**IN THE MATTER OF
ENVIRONMENTAL ASSESSMENT CERTIFICATE (CERTIFICATE) # E14-02
HELD BY BRITISH COLUMBIA HYDRO AND POWER AUTHORITY**

**FOR THE
SITE C CLEAN ENERGY PROJECT**

**AMENDMENT # 7 (AMENDMENT)
TO CERTIFICATE # E14-02**

Figure 4.28 Rev 1: Highway 29 Realignment – Lynx Creek Segment

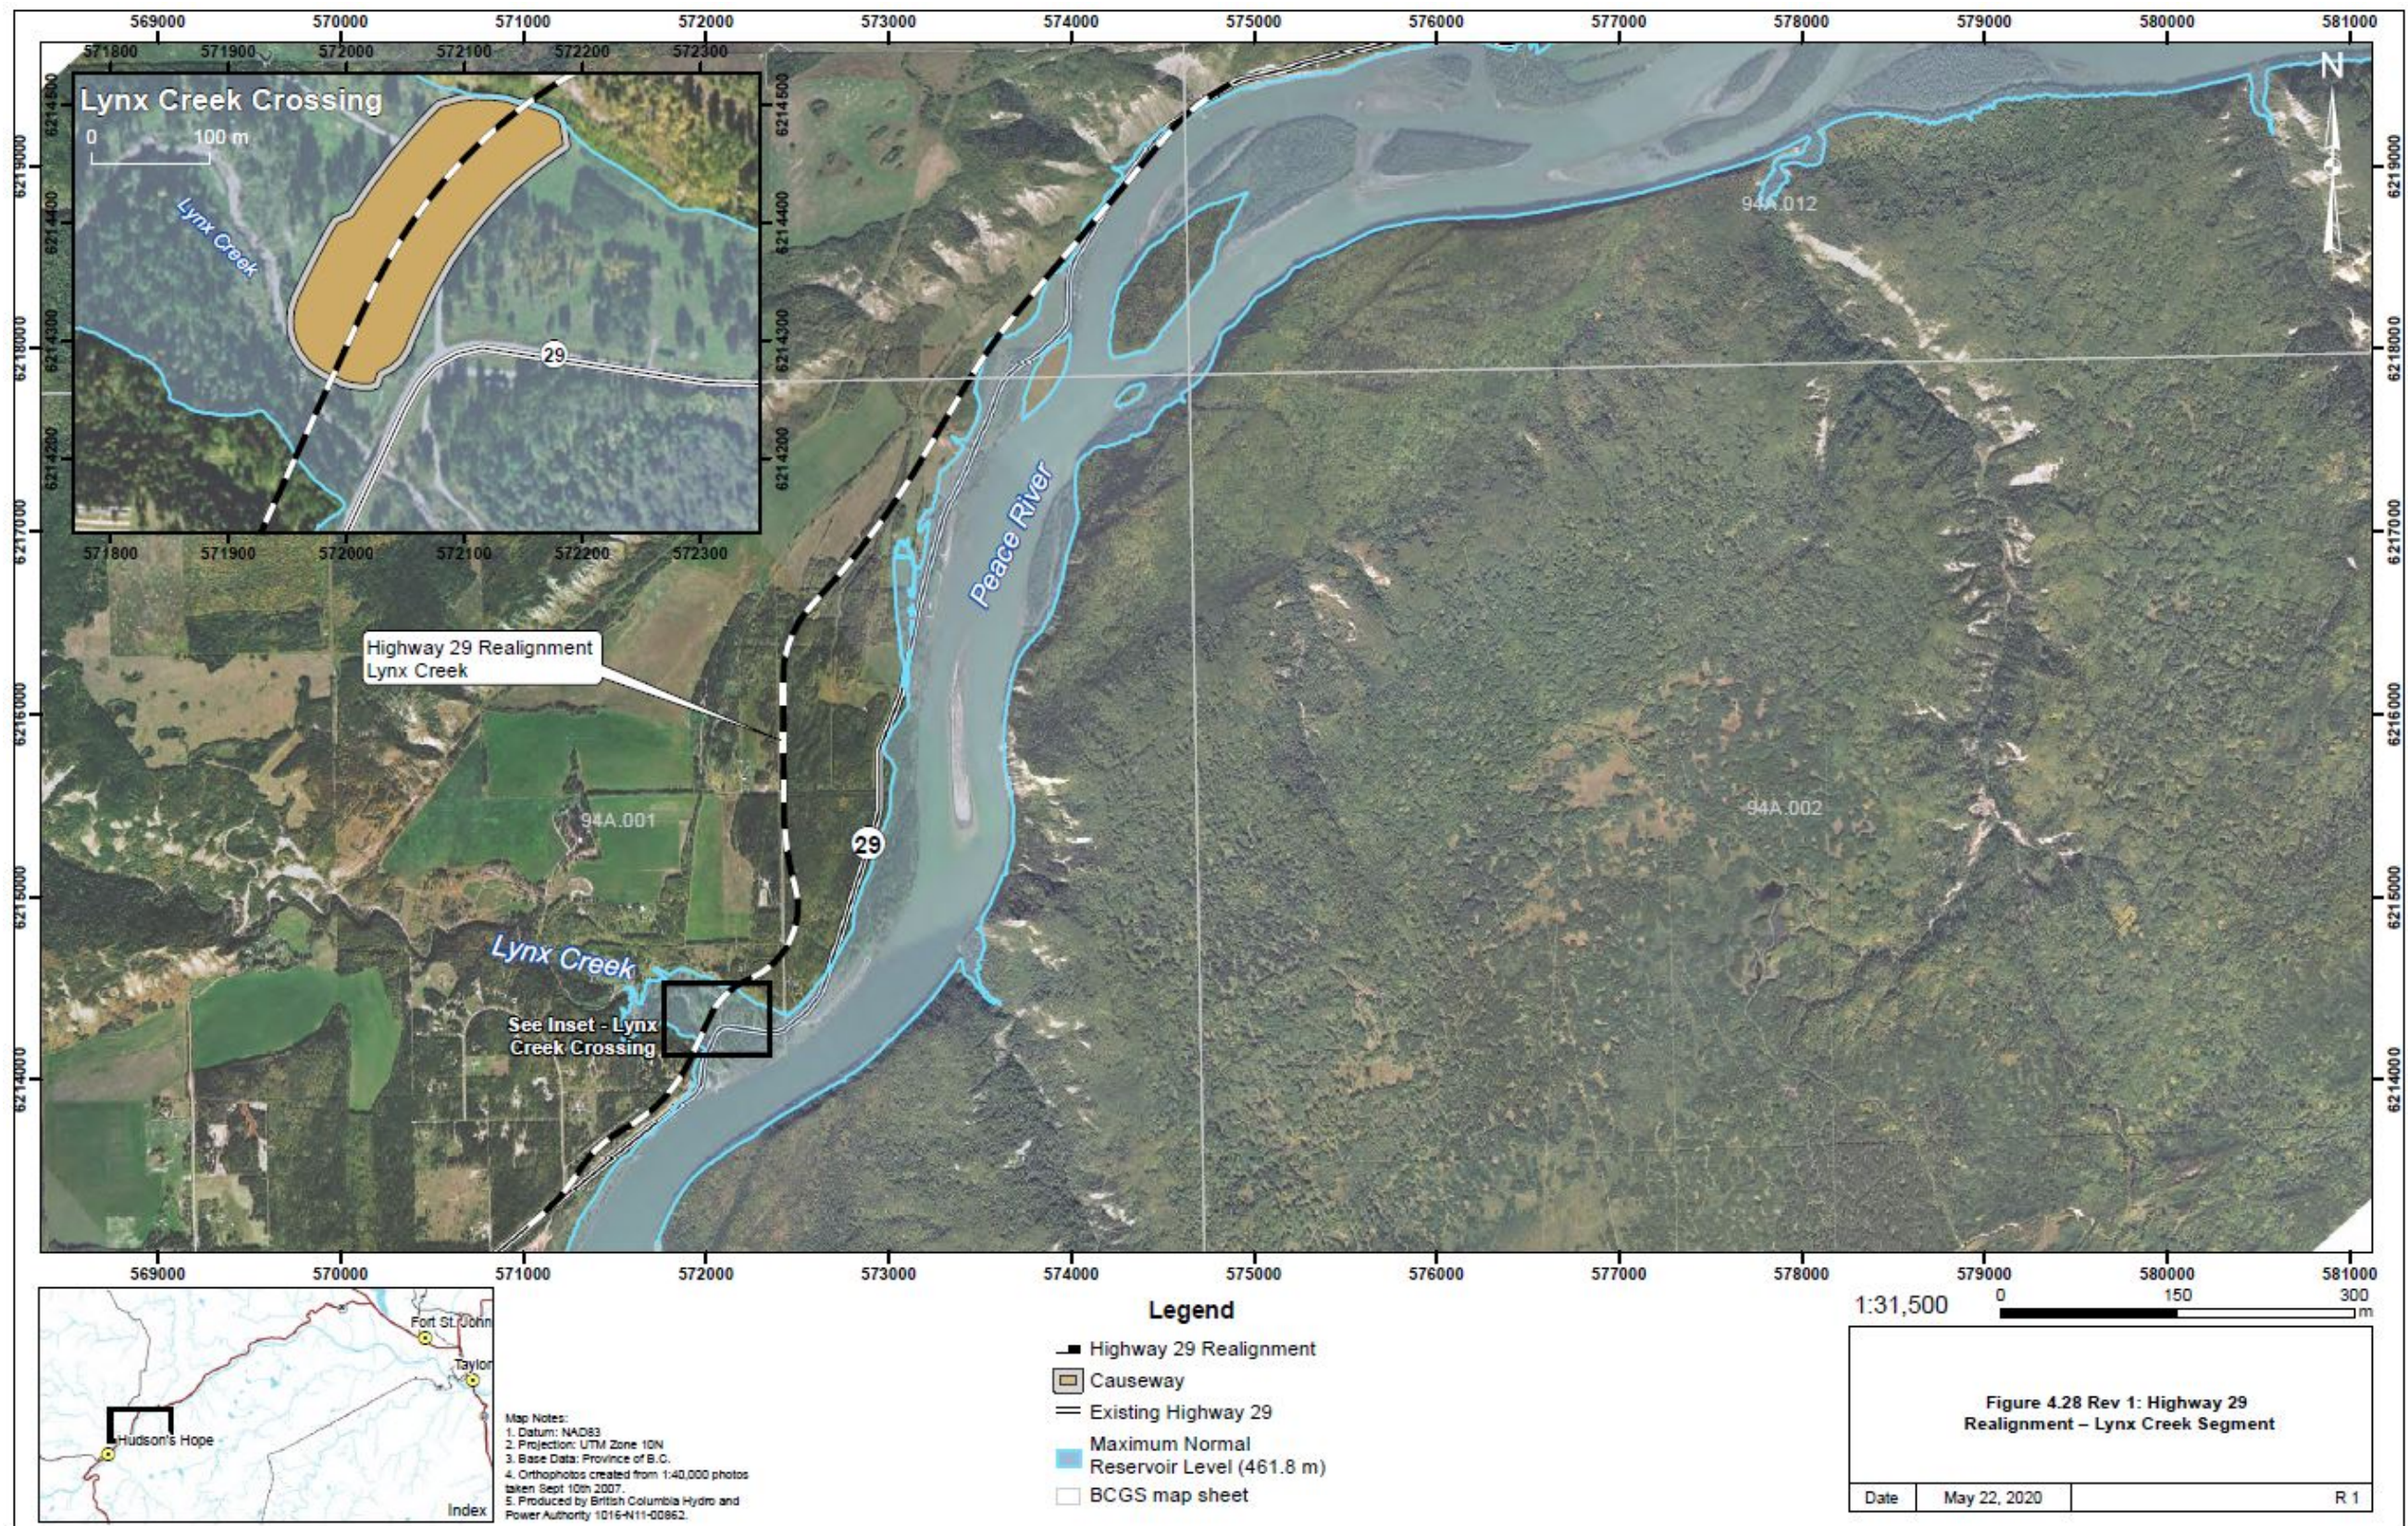
1. For the following headings, the information specified for “Segment Lynx Creek” in Table 4.5 in Section 4.3.4.1 of Schedule A (Project Description) is rescinded and replaced with:
 - Causeway Length (m) “up to 290”
 - Bridge Length (m) “up to 180”
 - Number of Piers “up to 3”
 - Bridge Span “up to 4”
 - Figure Number “Figure 4.28 Rev 1”

4. “Figure 4.28” in Schedule A (Project Description) is rescinded and replaced with “Figure 4.28 Rev 1” in Appendix A of this Amendment.

Figure 4.30 Rev 1: Highway 29 Realignment – Farrell Creek Segment

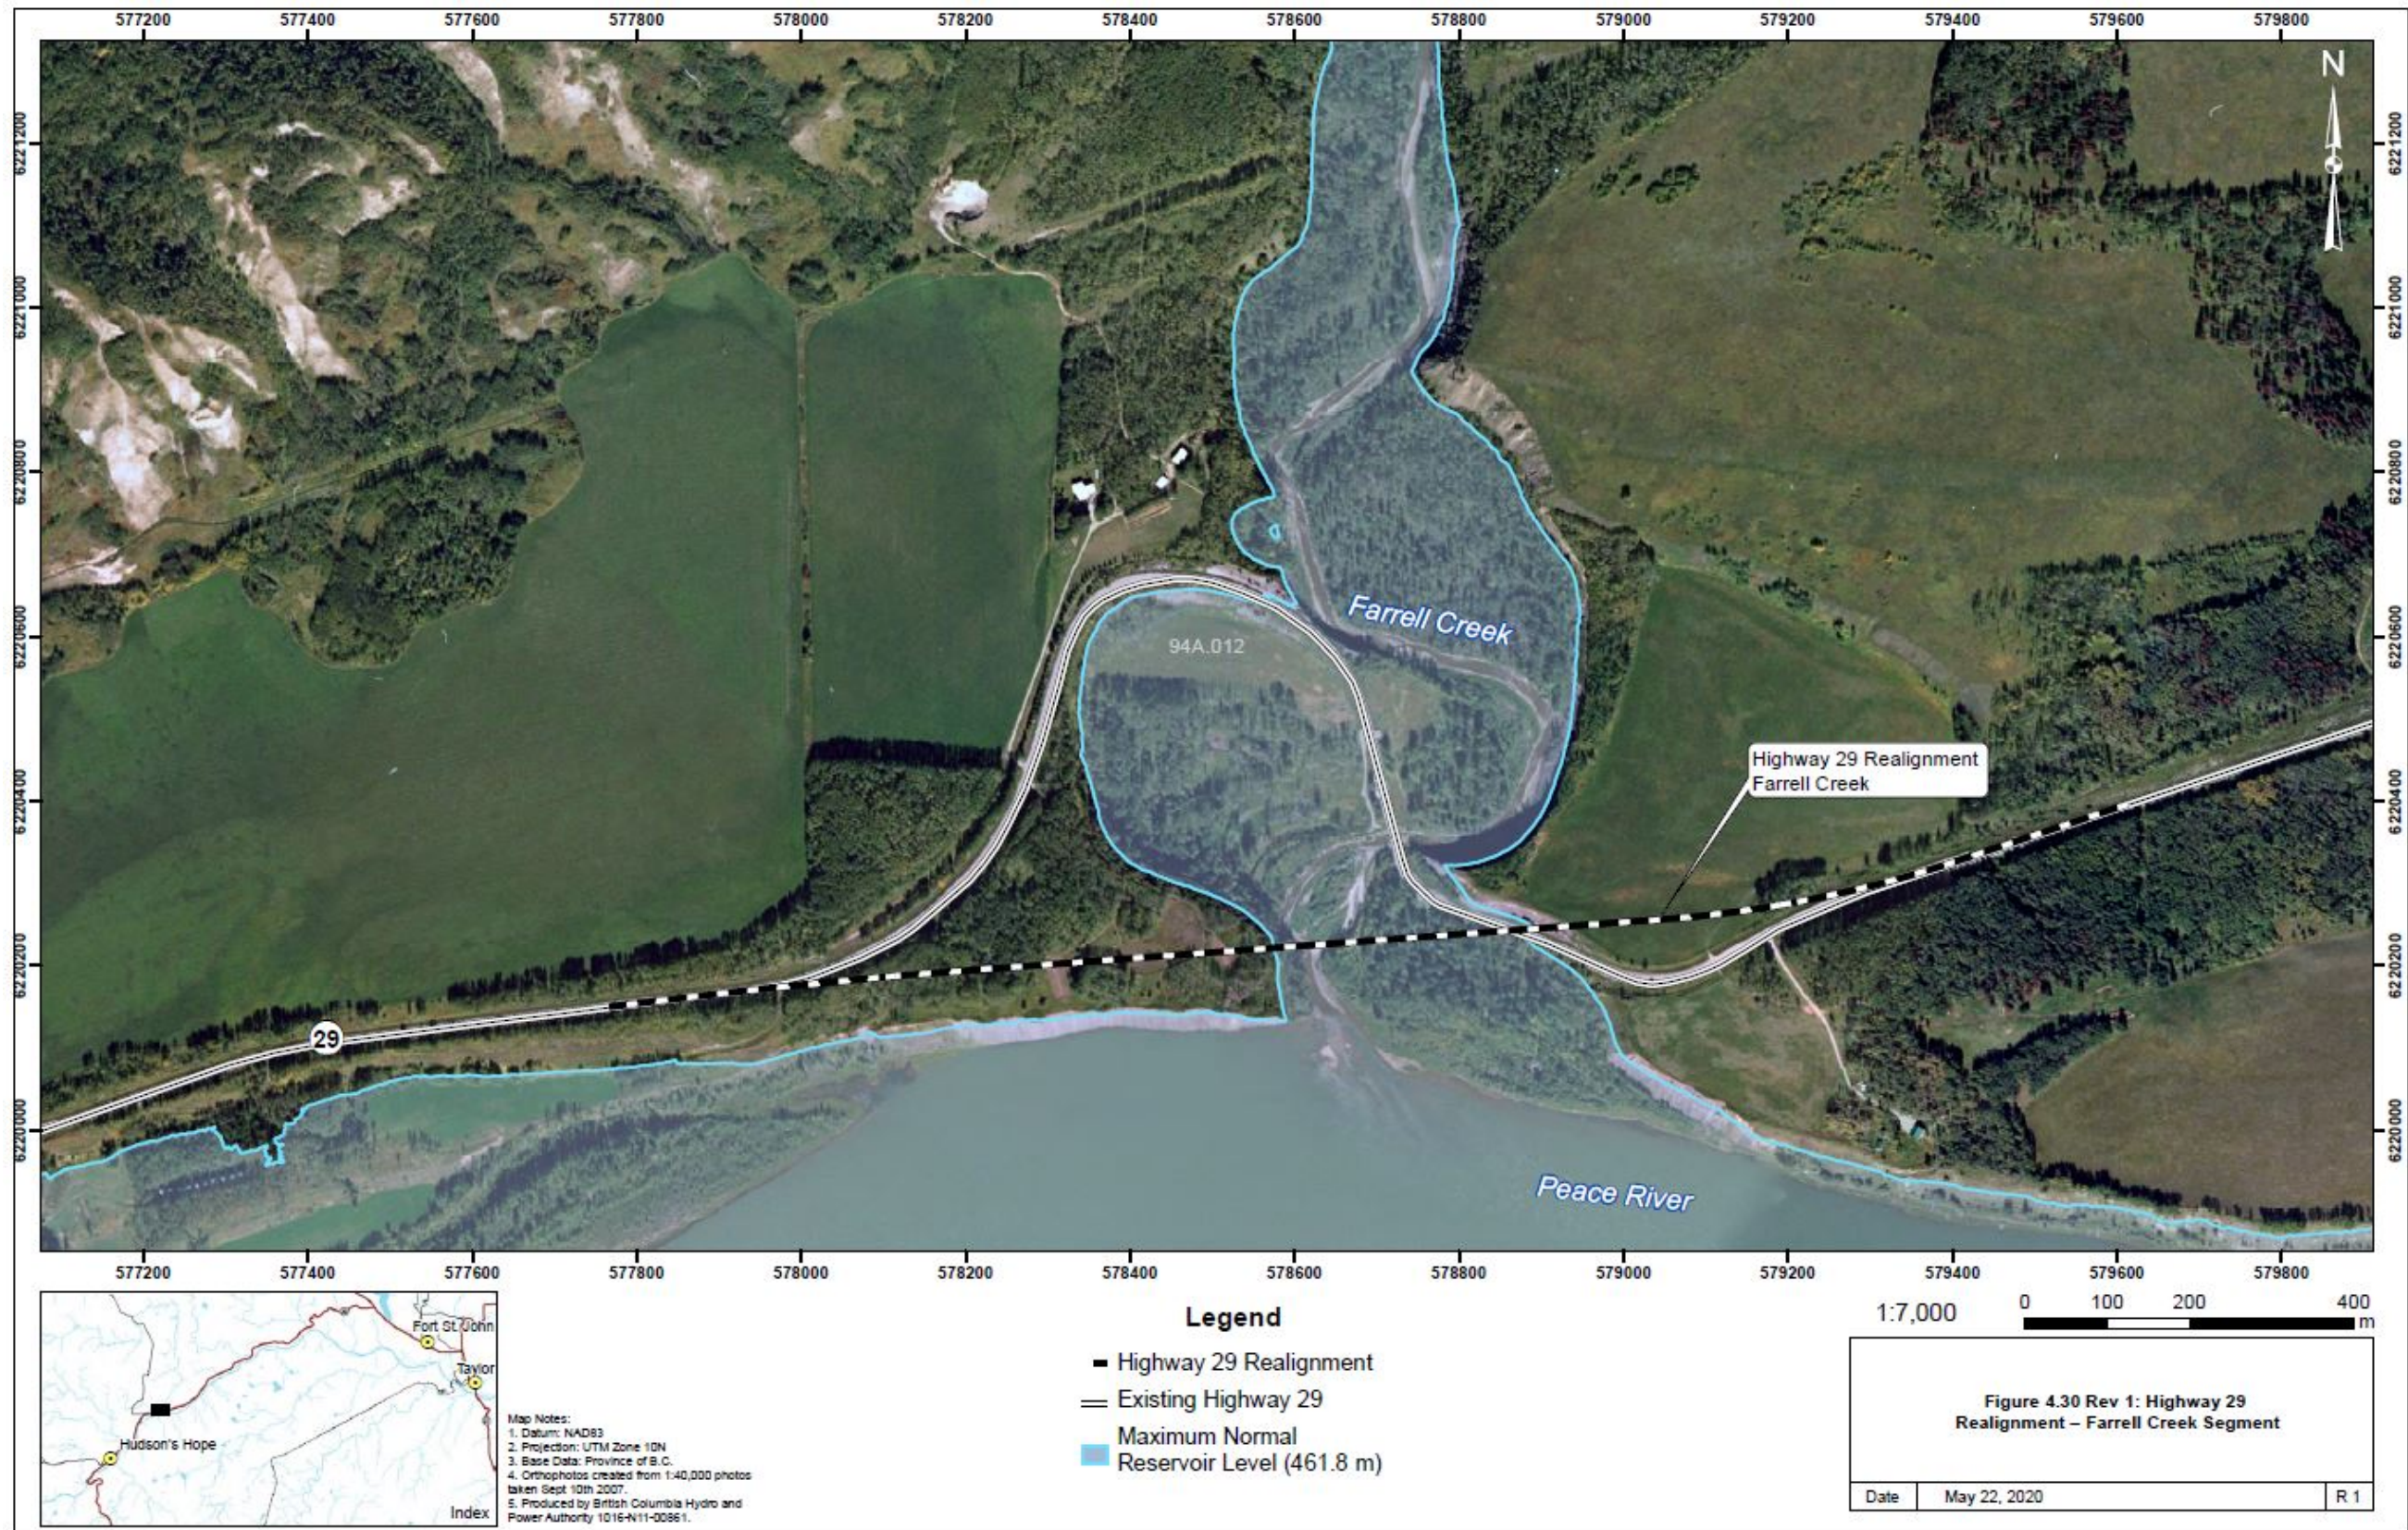
3. For the following headings, the information specified for “Segment Farrell Creek” in Table 4.5 in Section 4.3.4.1 of Schedule A (Project Description) is rescinded and replaced with:
 - Causeway Length (m) “0”
 - Bridge Length (m) “up to 450”
 - Number of Piers “up to 6”
 - Bridge Span “up to 7”
 - Figure Number “Figure 4.30 Rev 1”

6. “Figure 4.30” in Schedule A (Project Description) is rescinded and replaced with “Figure 4.30 Rev 1” in Appendix A of this Amendment.
